In the Matter of
METROPOLITAN EDISON COMPANY
(Three Mile Island Nuclear Station, Unit No. 1)
Docket No. 50-289 (Restart)

1. Letter, R. C. Arnold/GPU Nuclear to William Lowe/Pickard, Lowe & Garrick re "Investigation of Potential Safety Issues - TMI-2," dated March 4, 1983, and Attachment.

Appendix A
Polar Crane Considerations
Responses

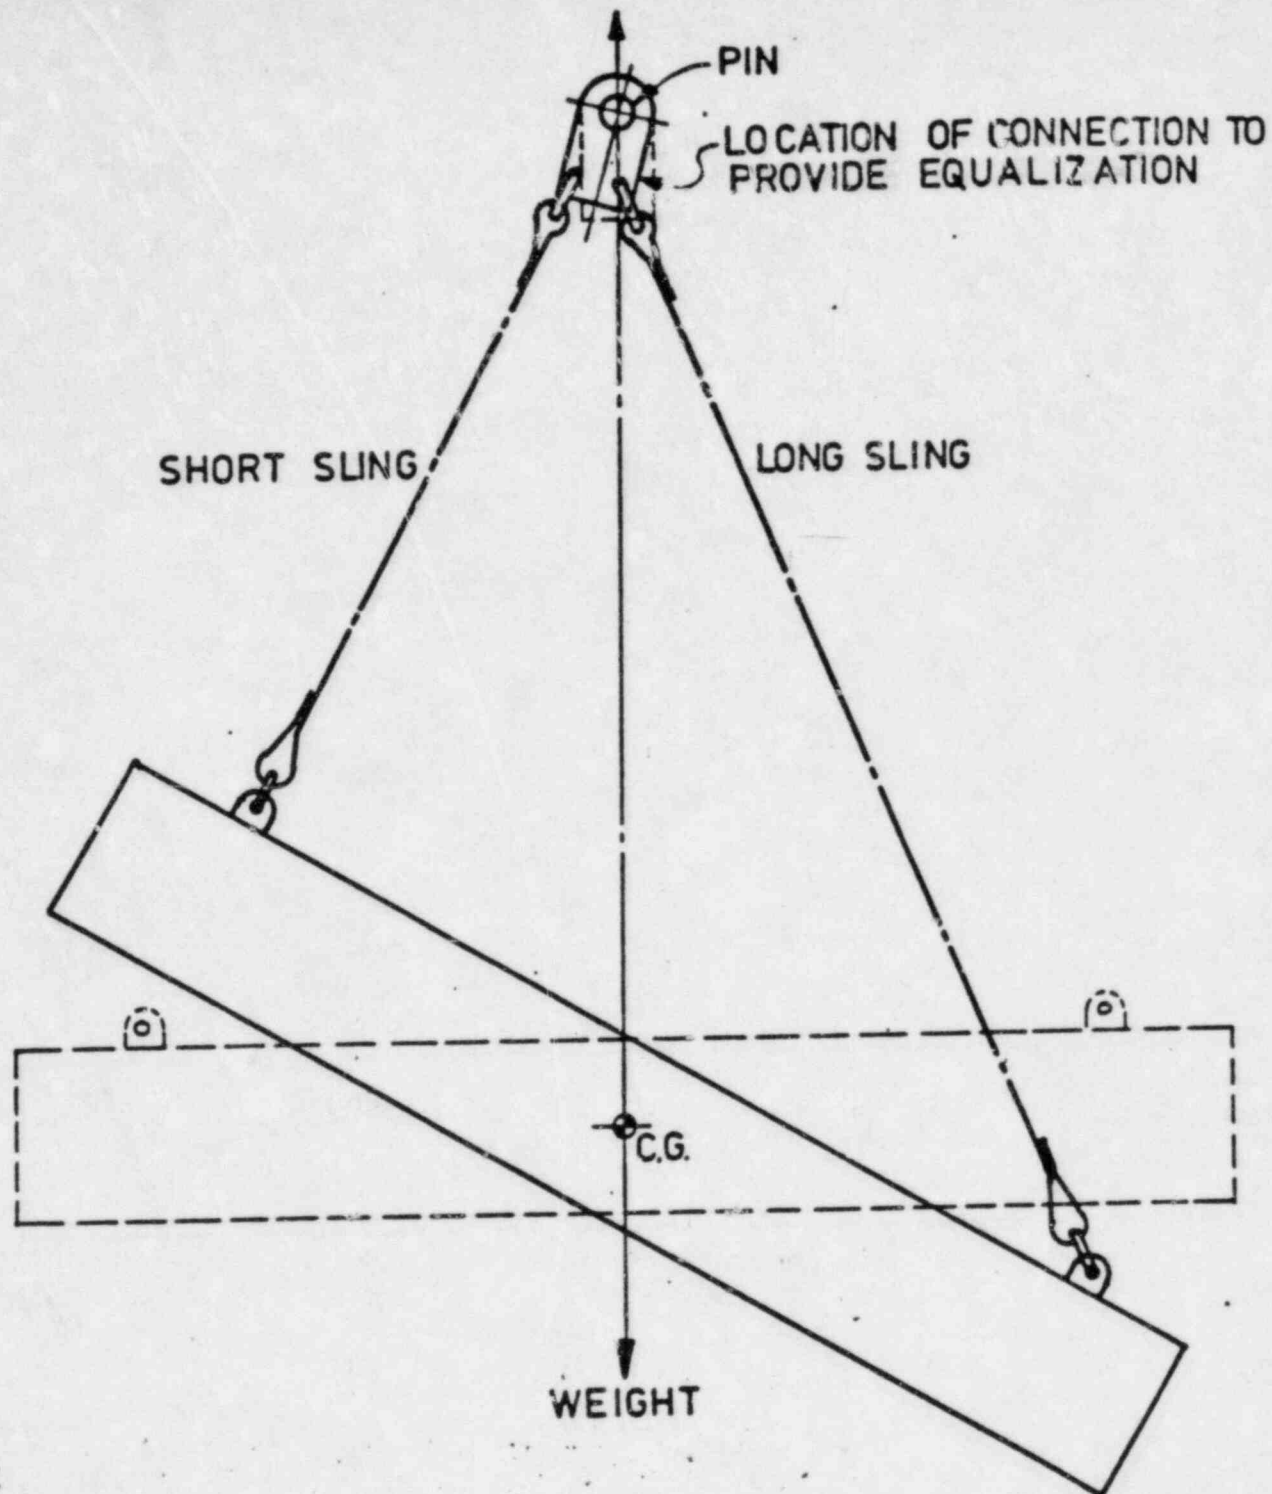
We find no precedent for NDE of the unwelded links in the rigging which are fabricated of plate steel. This is a tough ferritic steel which is not particularly susceptible to crack propagation.

As a result of undersized welds which were discovered on the Crystal River tripod, (of essentially identical design to the TMI-2 tripod) a dimensional check of the corresponding welds will be performed. The welds in question (see Figure 4) are shown on the attached sketch.

EQUALIZATION ALONG LONGITUDINAL DIRECTION

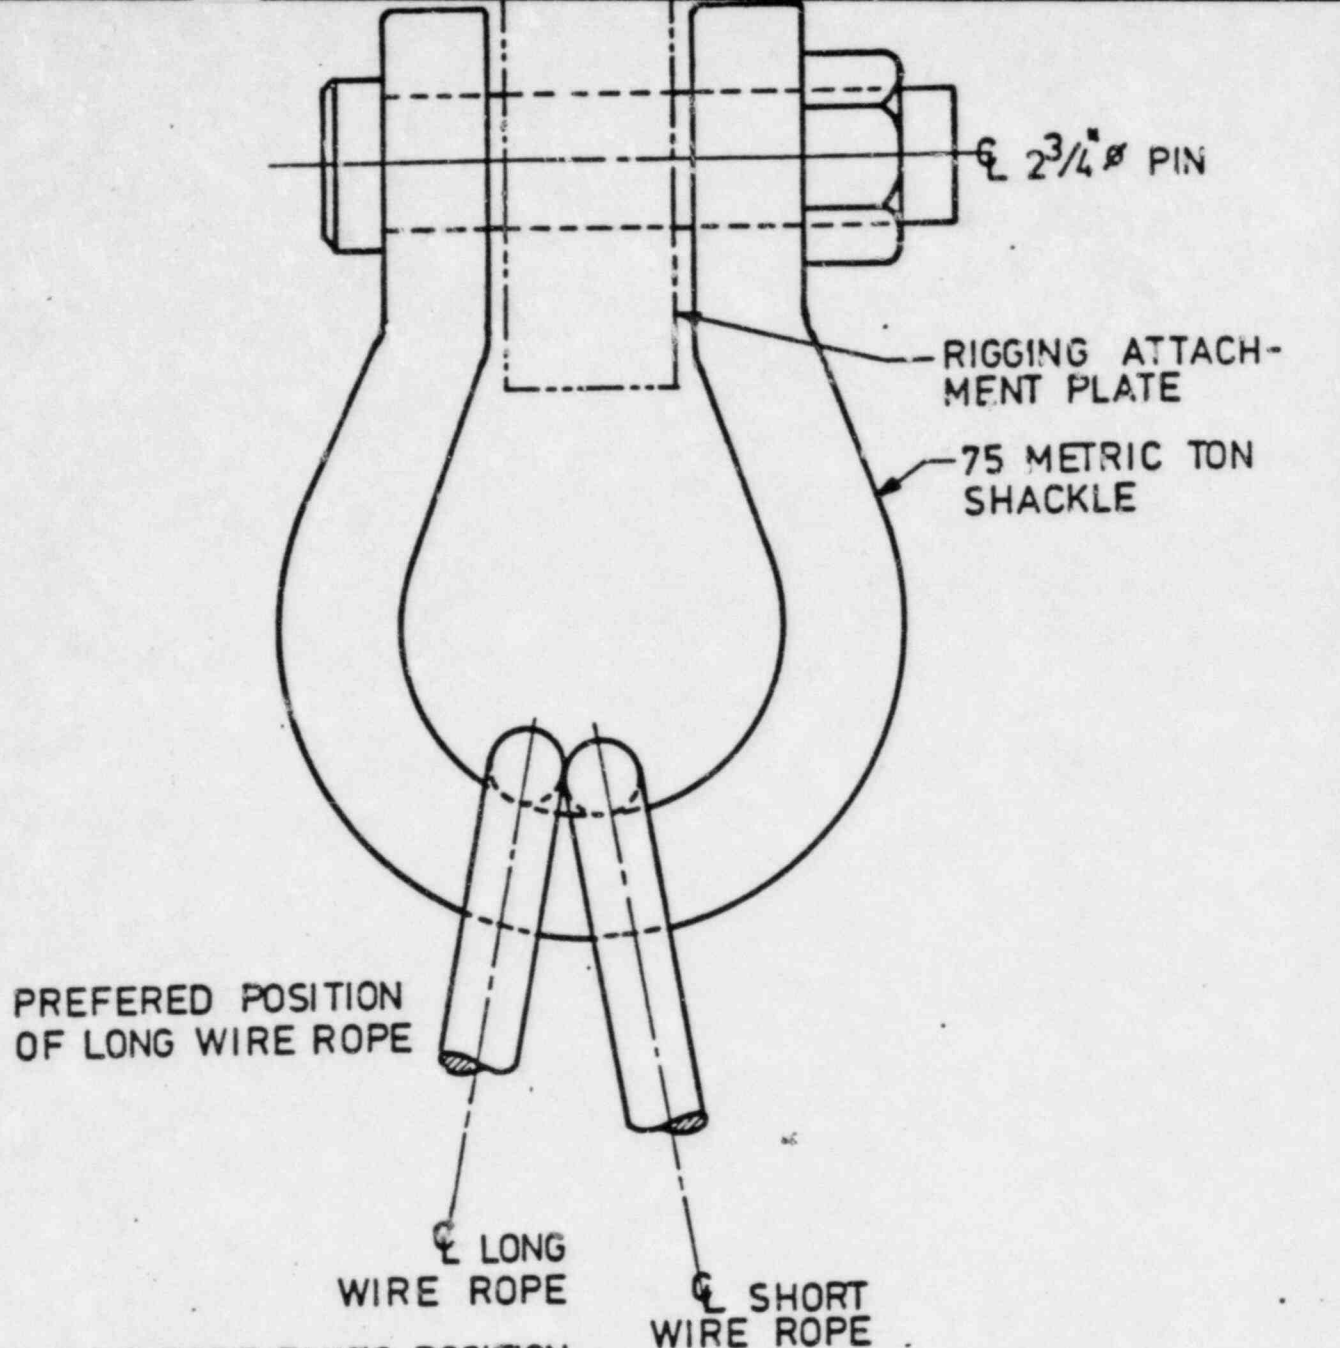
3. The four (4) wire rope slings designed to lift the missile shields were furnished equal length within a tolerance of $\pm 1/8"$ per supplier certification. In addition, the rigging for the missile shields has been designed with load equalizing capabilities built-in. Bechtel Drawing 2-COP-1302, Rev. 2, shows the details of the Missile Shield Rigging Attachment Plate (Detail 5) using a pair of two-leg bridles rather than a single four-leg bridle. Therefore, the rocking action of the attachment plate (see Enclosure 1 attached) about its single pin and the two Crosby shackles, with two sling eyes each in the bail (see Enclosure 2 attached), provide equalizing action to accommodate the tolerance in the sling lengths.

DIFFERENCE BETWEEN SLING LENGTHS GREATLY EXAGGERATED TO SHOW EQUALIZATION EFFECT. ACTUALLY THE DIFFERENCE IN SLING LENGTHS IS LESS THAN 0.123%.
